**Product Change Notice**

PCN#: EE-PCN23006

2/28/2023

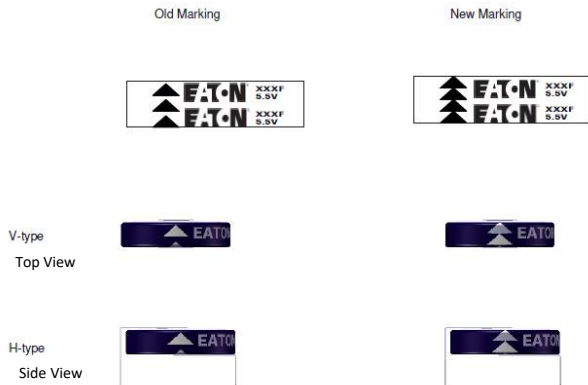
Change product label marking. The change eliminates spaces between the markings which point to the negative lead.
